Awel y Môr Offshore Wind Farm

Application Errata List (Clean)

Deadline 8

Document Reference: 8.39

FIGURE NUMBER:
Figure 1

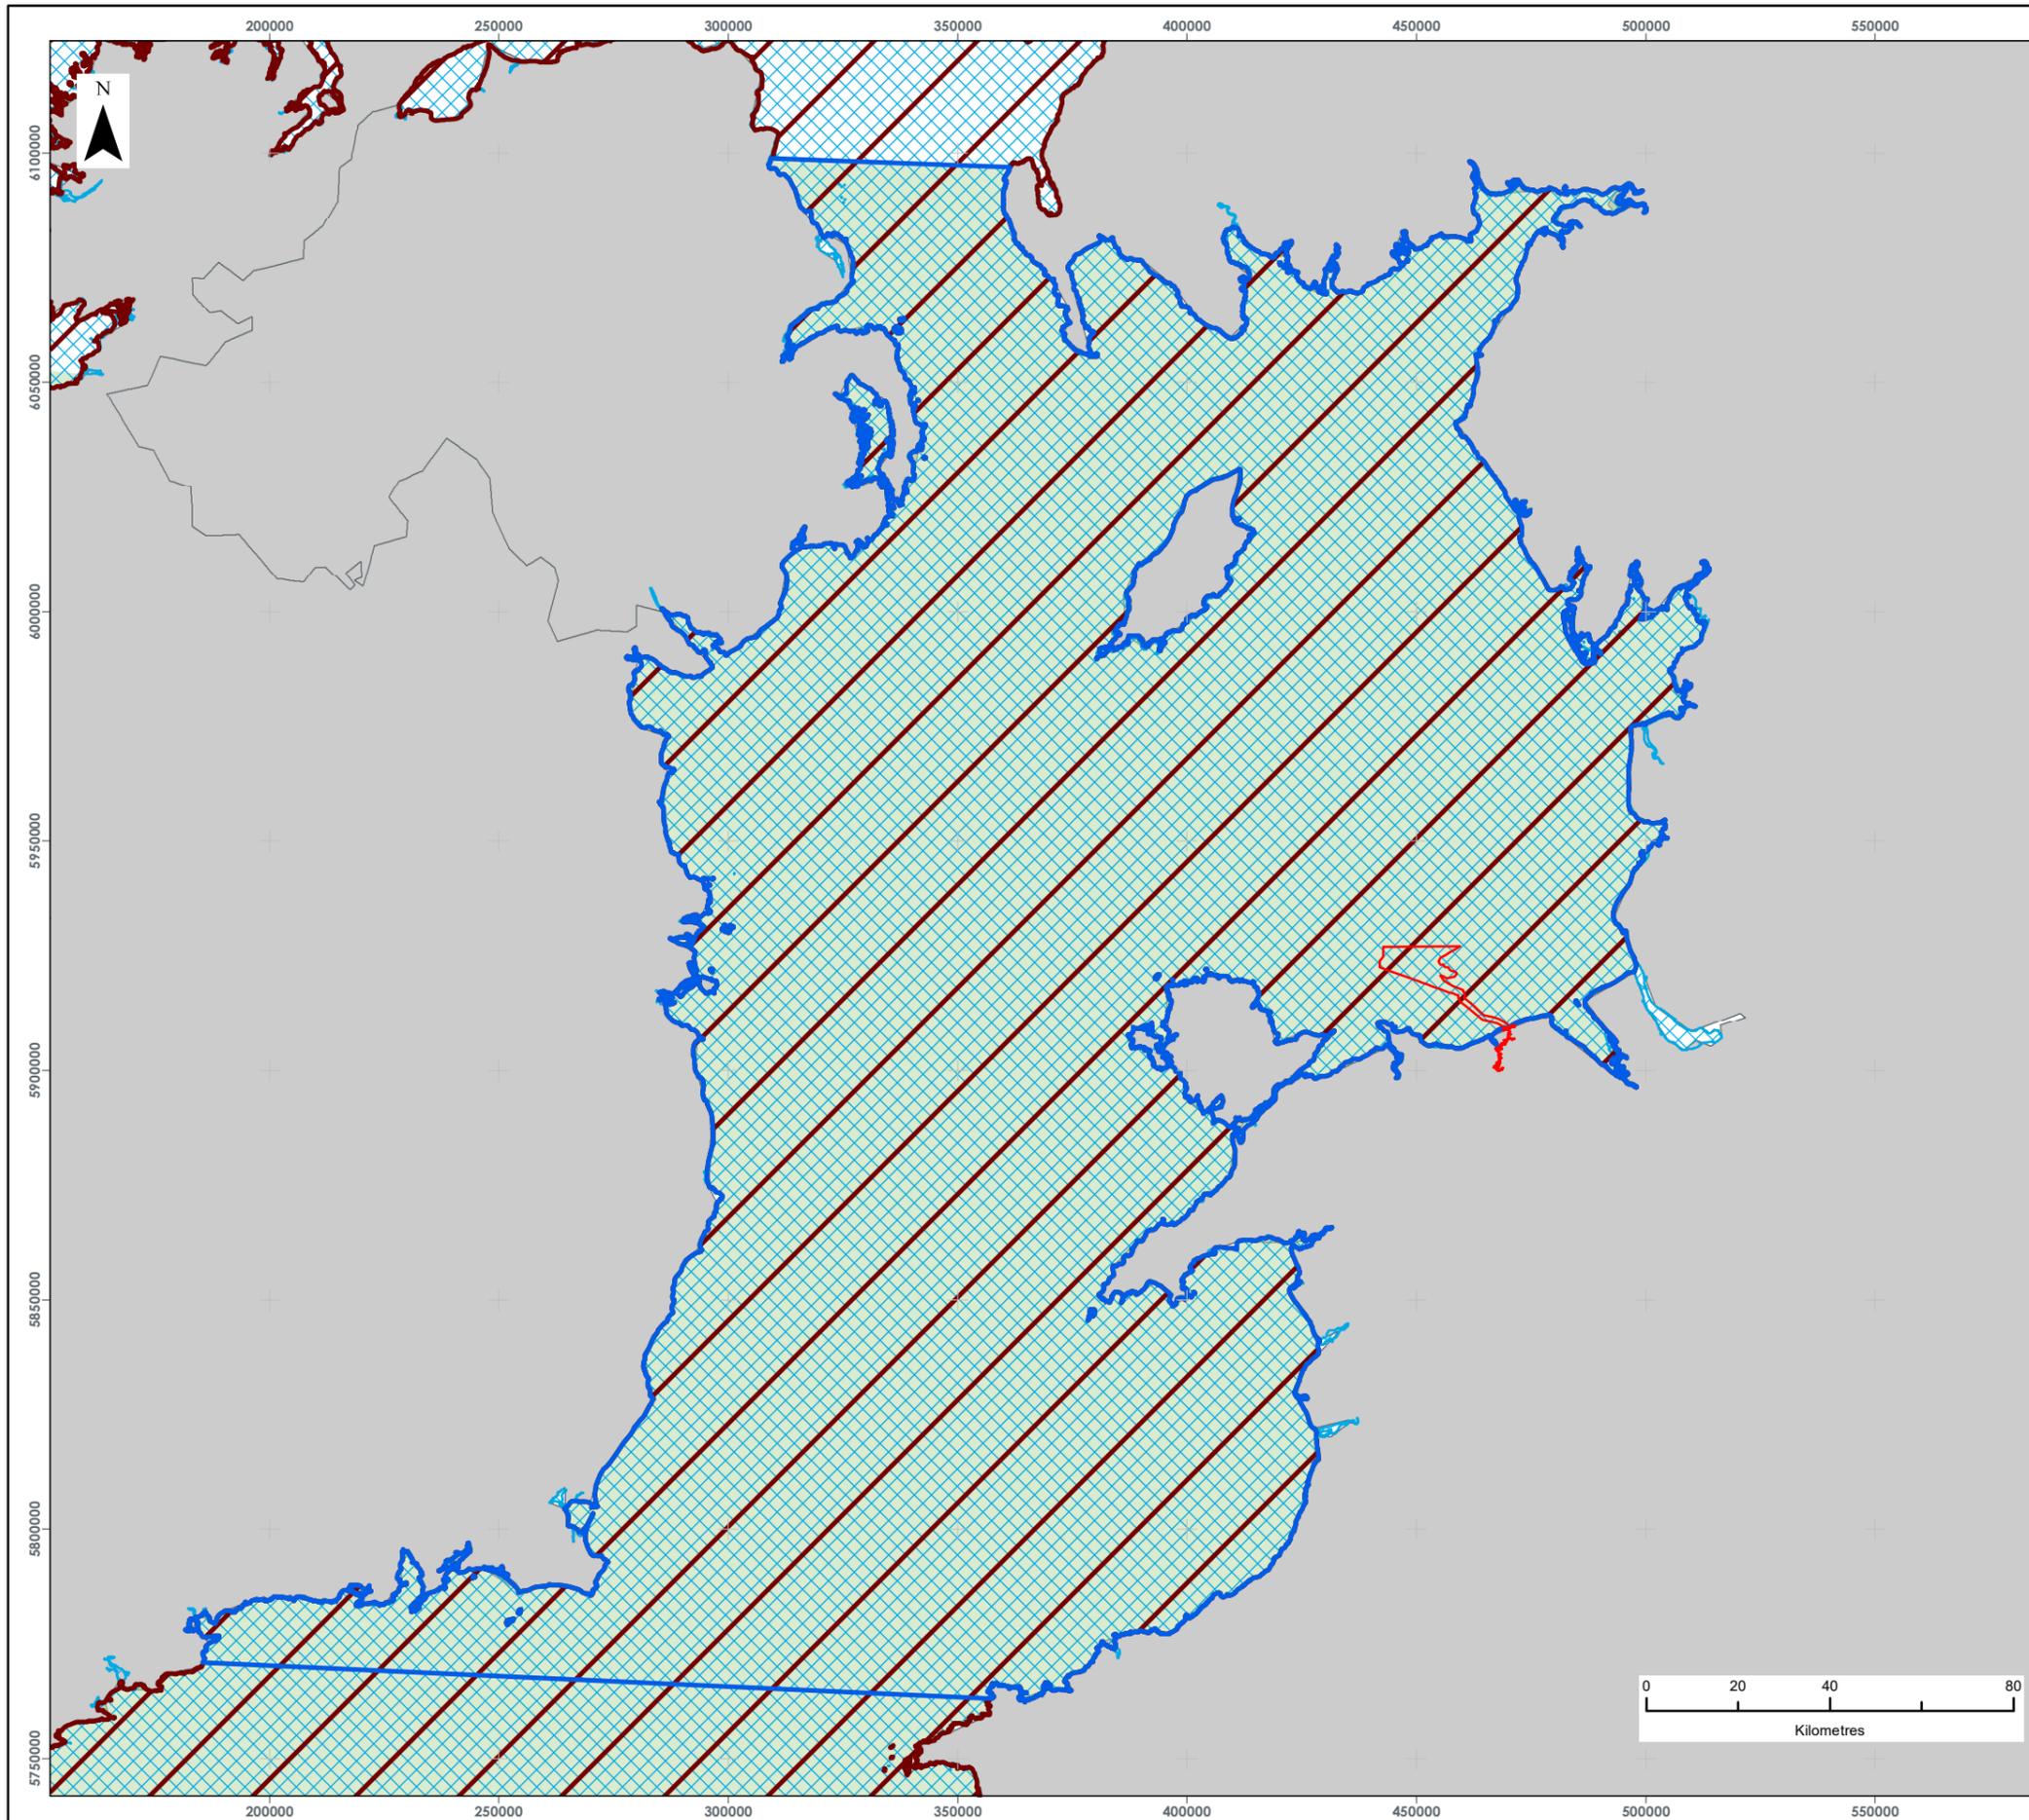
- 8 For completeness, the correct figures are appended to this document in Appendix A, duplicated from the figures presented in APP-053:
 - ✦ Figure 1: Figure incorrectly displayed a black background and omitted base mapping. Corrected figure provided in Appendix A of this document. Note this figure is identical to Figure 1 presented in APP-053.

FIGURE NUMBER:
Figure 2

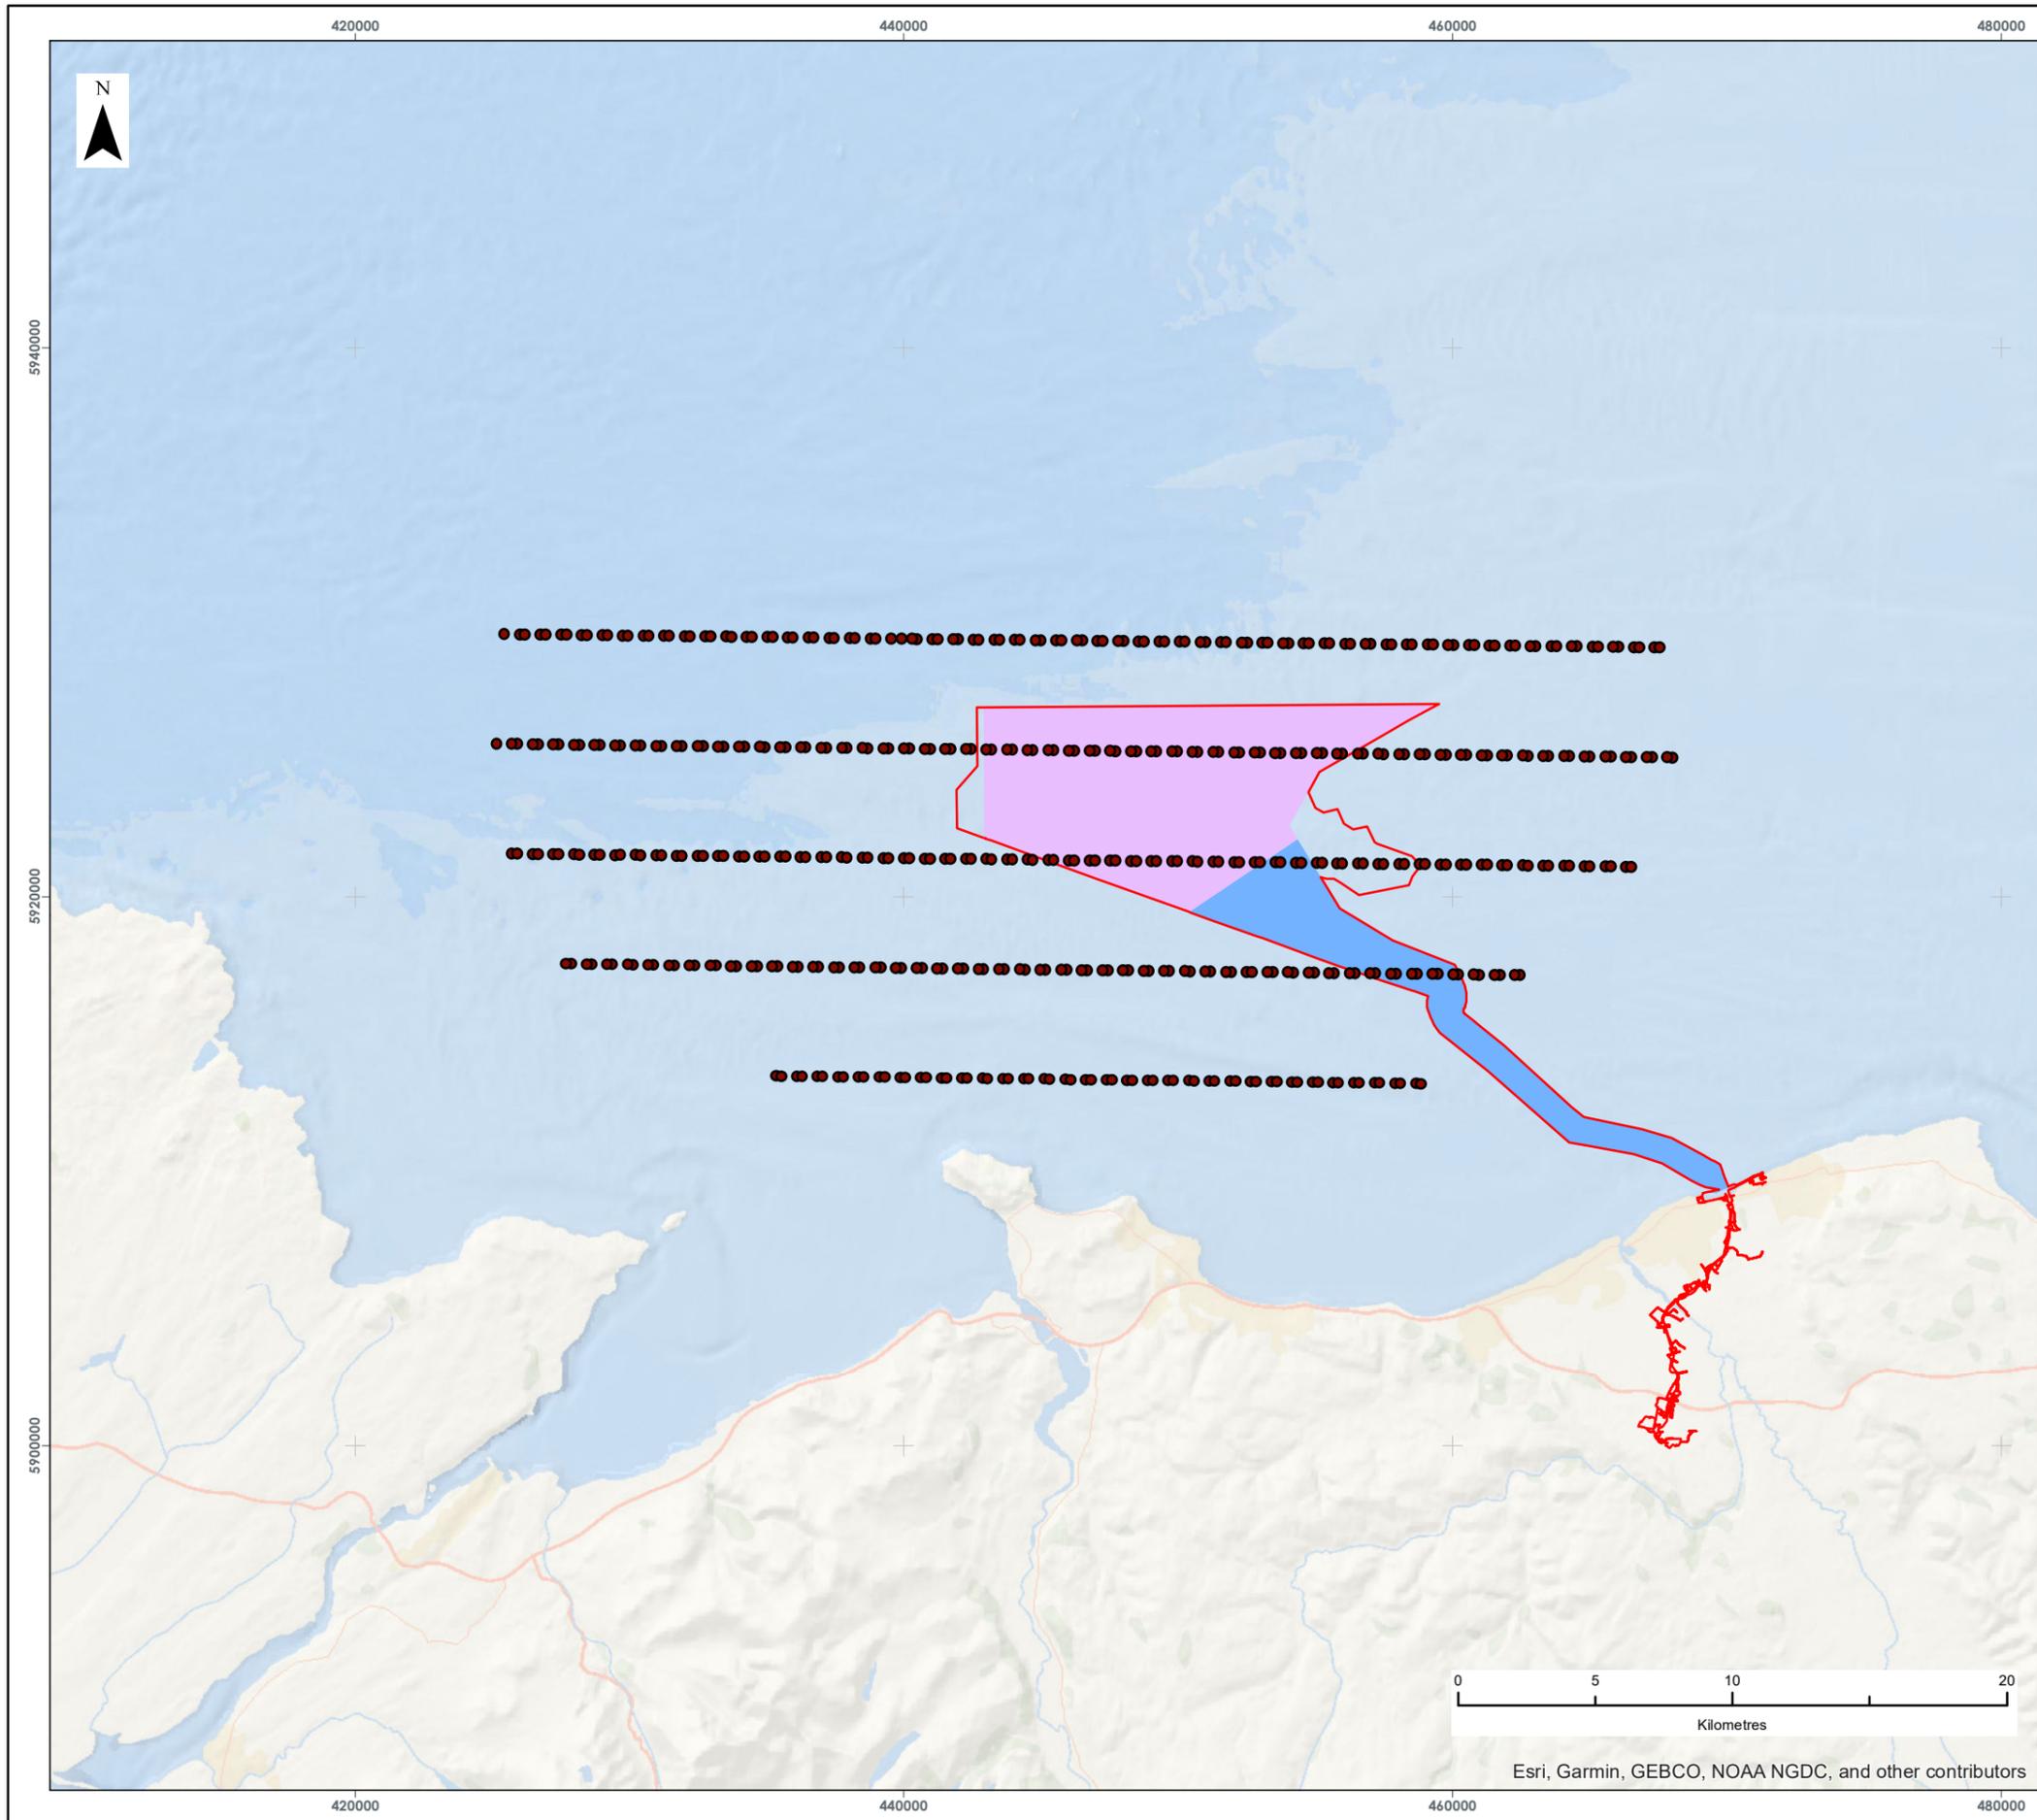
- ▲ Figure 2: Figure incorrectly displayed a black background and omitted base mapping. Corrected figure provided in Appendix A of this document. Note this figure is identical to Figure 2 presented in APP-053.

FIGURE NUMBER:
Figure 18

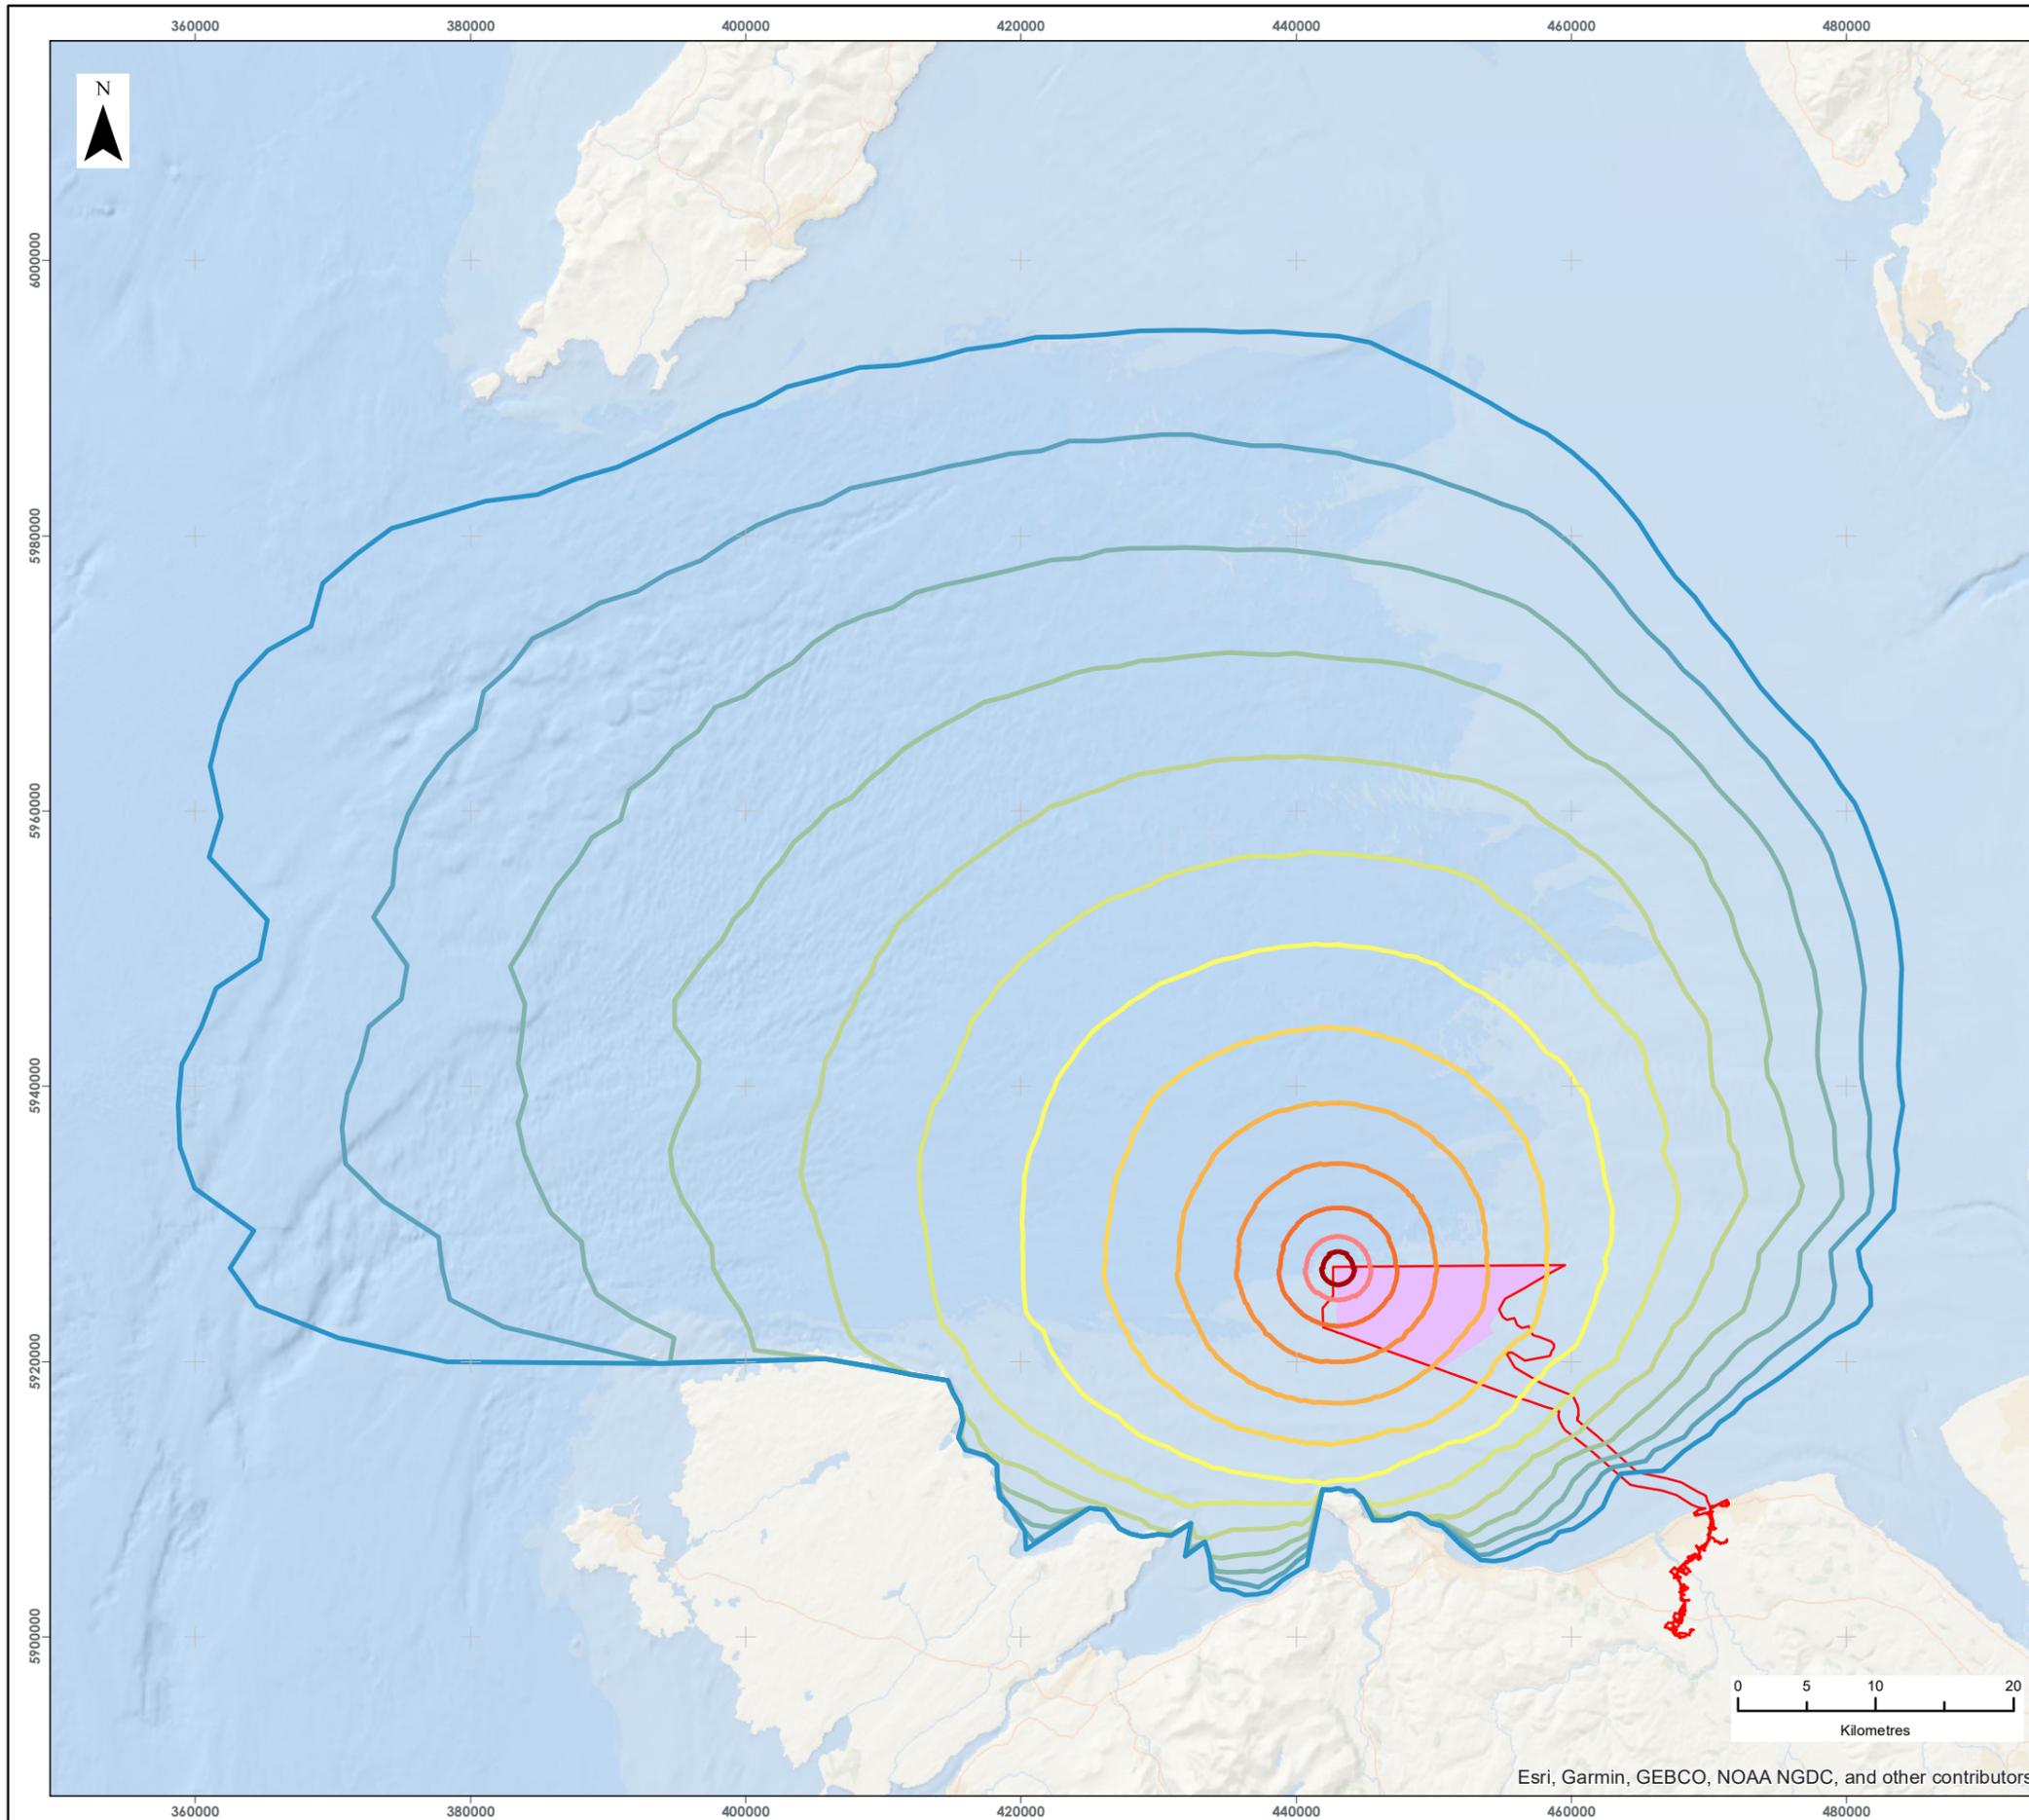
- ▲ Figure 18: Figure incorrectly displayed a partial black background and omitted base mapping. Corrected figure provided in Appendix A of this document. Note this figure is identical to Figure 18 presented in APP-053.
